Reply to the editor

We would like to thank the editor for the constructive comments on our revised manuscript. We have also found missing Fig. 18 in manuscript. We added it (L422). And we added A. Sakai as second corresponding author (L9, 18-19, 494-497). We also described the detail in the Author contributions.

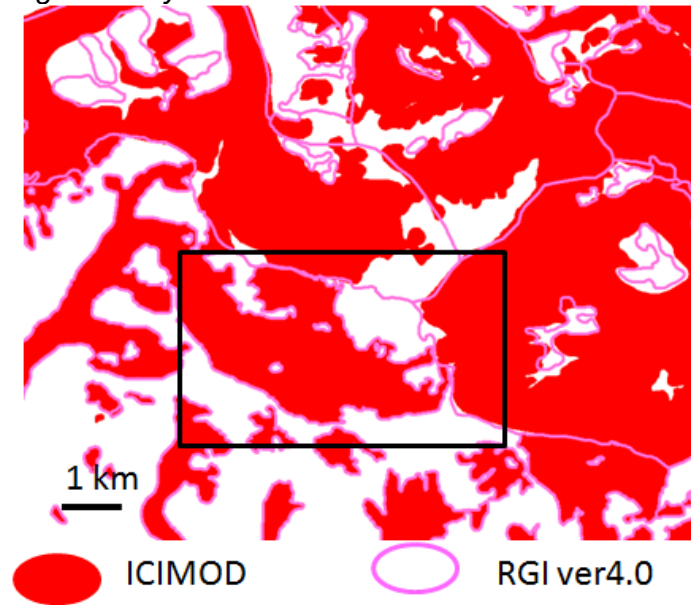
Fig. 5: Can you also show/mention the RGI outlines?

Above figure shows the glacier outlines from ICIMOD and RGI4.0. Black rectangular indicates the target of Fig.4 (number changed from 5 to 4) (accumulation area of the Khumbu glacier). Both outlines are same in the Khumbu glacier and those glacier outlines of only north and east of the Khumbu glacier are different, which is not target in Fig.4. Then, we only added the description about RGI ver4.0 as ‘Glacier outlines of RGI ver. 4.0 at the Khumbu Glacier is equal to the ICIMOD glacier inventory.’ (L665-666).
